Fwd: First bentonite notes ready to be sent to DRMS

Reclamation Notes on 11292016 Site Visit.pdf

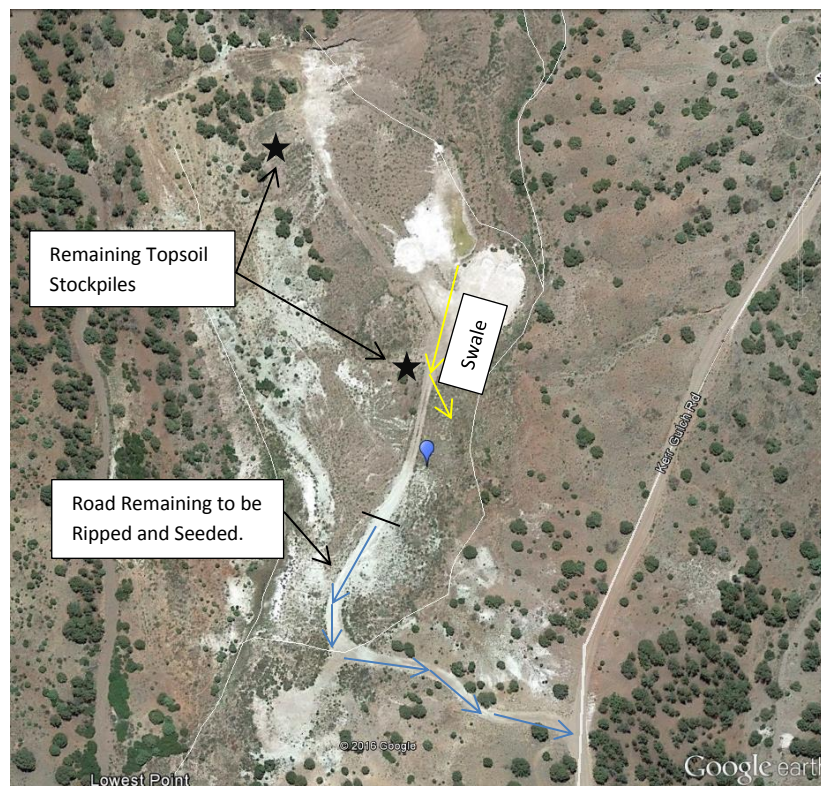
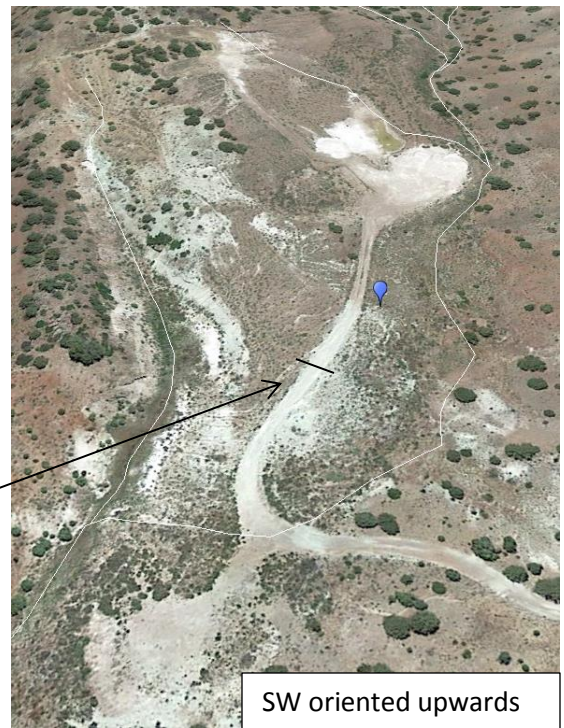
- Two stockpiles of soil were observed along the former route to the highwall from the staging area. The stockpiled material should be used in the ongoing reclamation efforts (this material could be used for the area where the product piles are currently being stored), so that there are no stockpiles remaining on the site.

Topsoil stockpile adjacent to the swale, near the former staging area.

Topsoil stockpile on the floor below the former highwall.

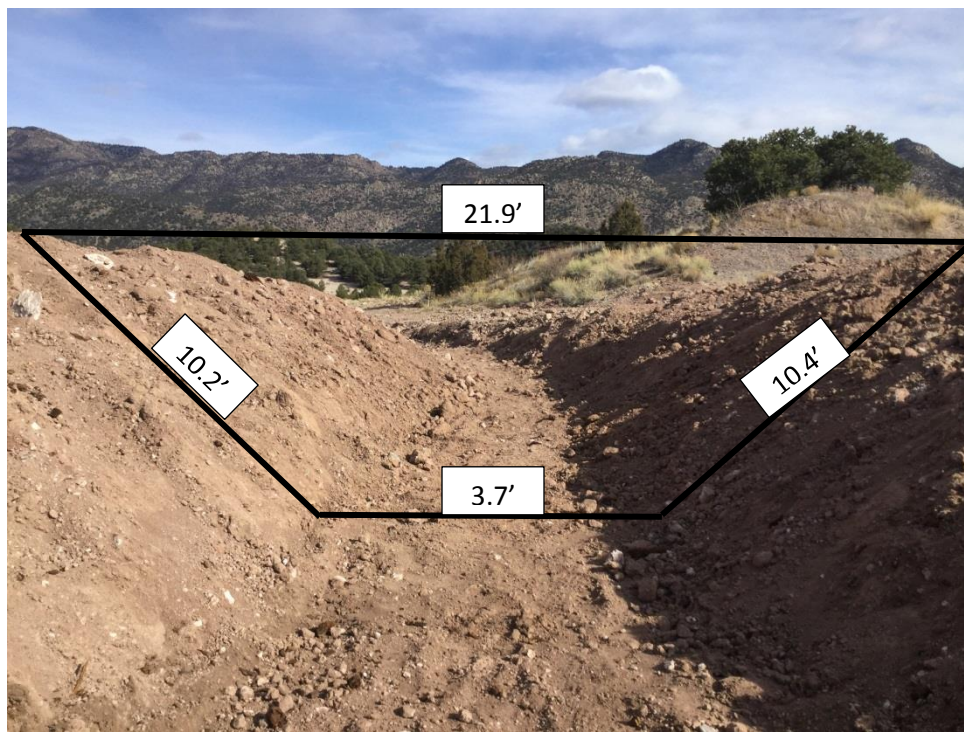
- The existing swale has been cut deeper to facilitate the site's drainage.

- Inverted trapezoidal cross-section notes (refer to figure):
 - 3.7' (base) x 10.2' (left diagonal) x 10.4' (right diagonal) x 21.9' (top)

- Approximate Area of Trapezoid = 61.76 ft^2
- Approximate volume of material removed for swale = $61.76 \text{ ft}^2 \times 160 \text{ ft (ground length)} = 9,881.6 \text{ ft}^3$ of material. The real number will be less than this because this assumes a constant depth (swale-bank top).

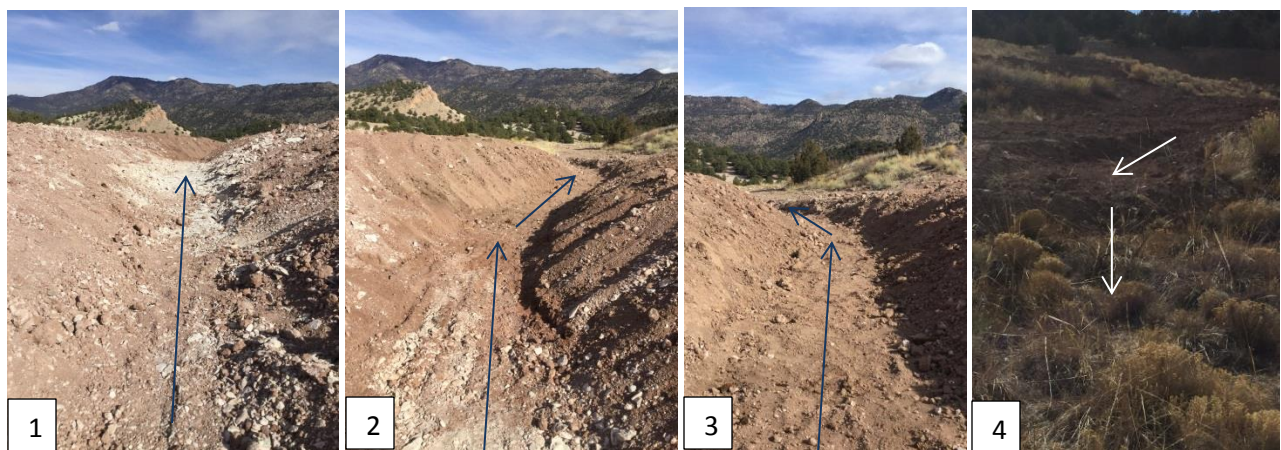
- In order for the water to drain through the swale's length, it appears that it will need to overtop 1.21 feet of vertical increase in the swale channel. It should be noted that this vertical increase is located at the beginning of the swale.

- The above photos show the sequence that water would take through the swale after overtopping the vertical increase of 1.21 feet at the beginning of the swale's channel. Photo 4 shows where the swale terminates into the pre-existing drainage basin.

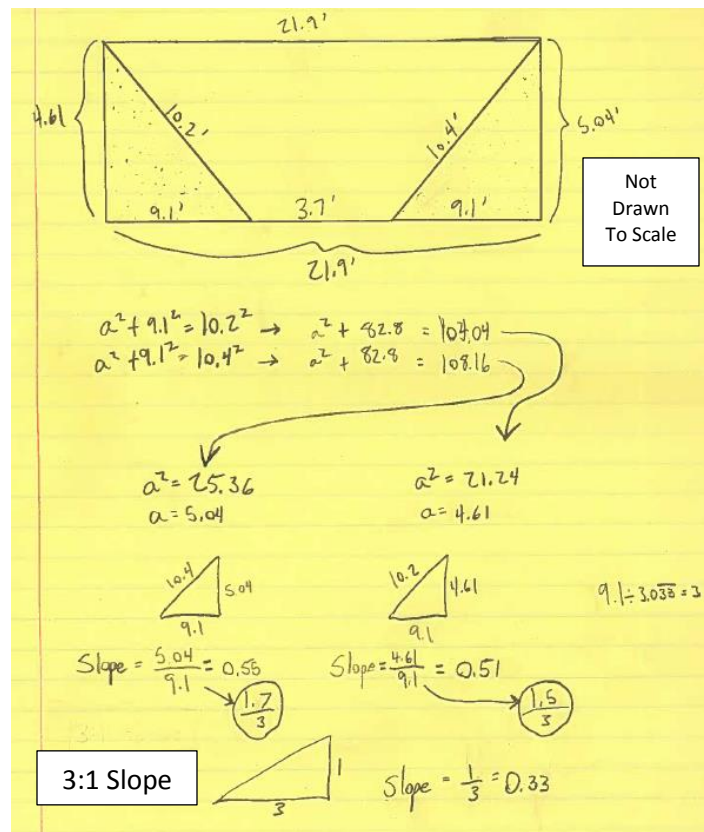
- Some reclaimed slopes exceed CDRMS' maximum slope of 3:1; however, the material is loose in these areas and will likely fill in towards the respective toe of each slope, making the slopes more gradual.
 - As we will have to wait for the growing season on the site's revegetation, it might be sufficient to monitor these slopes over the coming months.
- Swale side slopes are adequate (3 : 1.6).

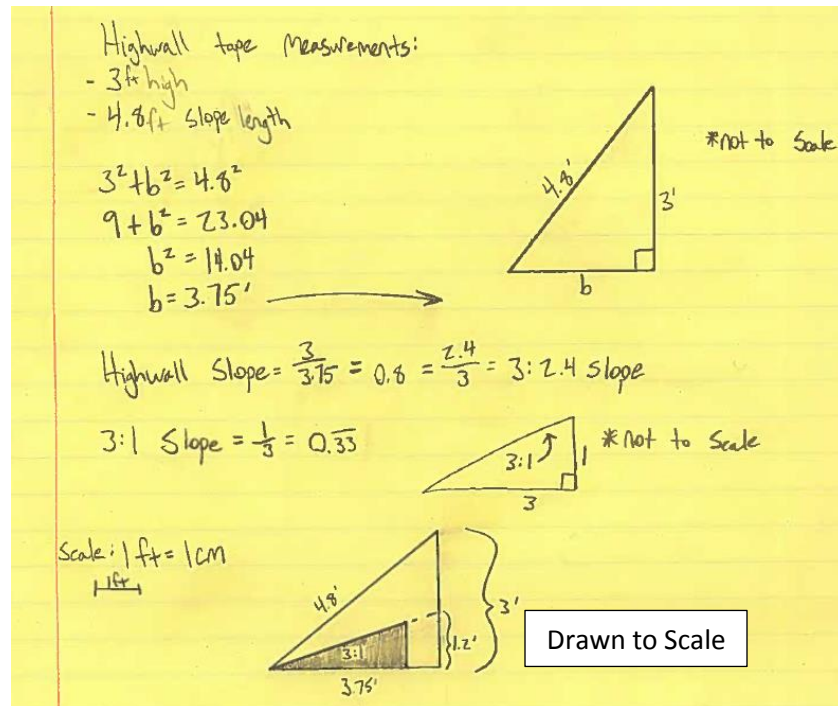
- The Highwall Slope at its steepest angle is $\leq 2 \times$ greater the CDRMS 3:1 slope standard. Refer to the scaled triangle at the base of the figure, which compares a 3:1 slope (shaded) and the current slope of the highwall.

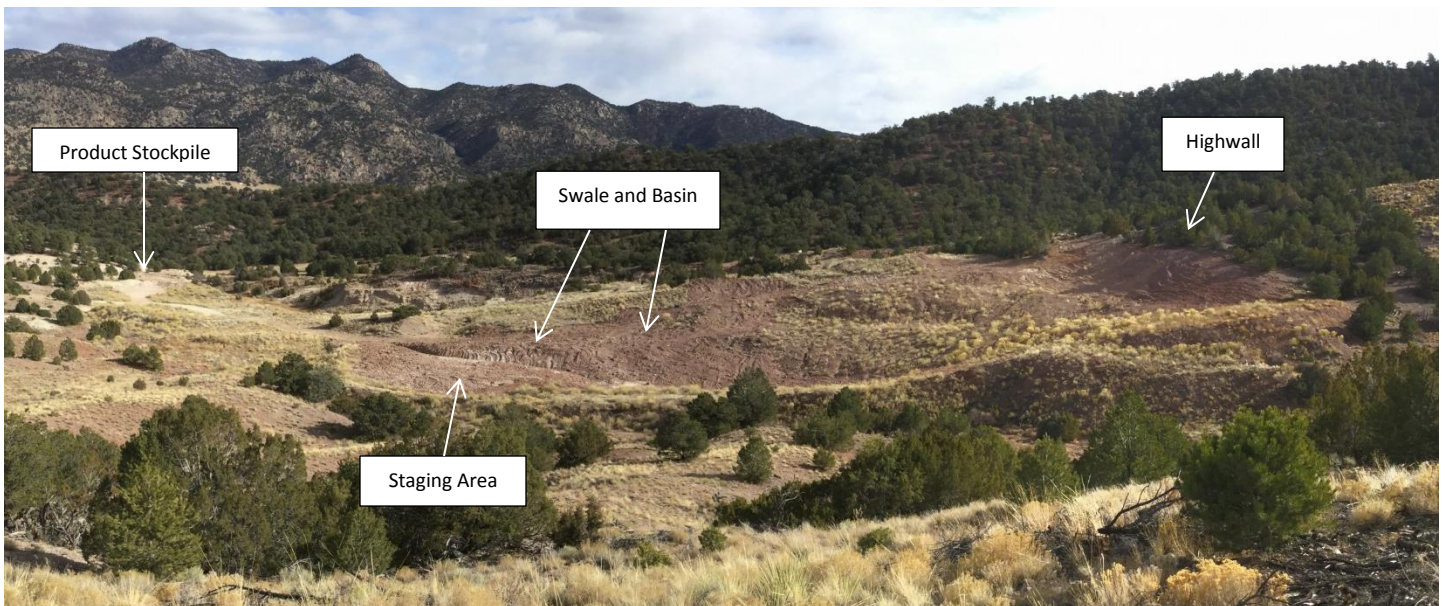
- From a visual standpoint, the grading and re-contouring efforts appear to have been successful. From Kerr Gulch Rd., the previous disturbances appear to be well blended with the surrounding topography (see photo below).
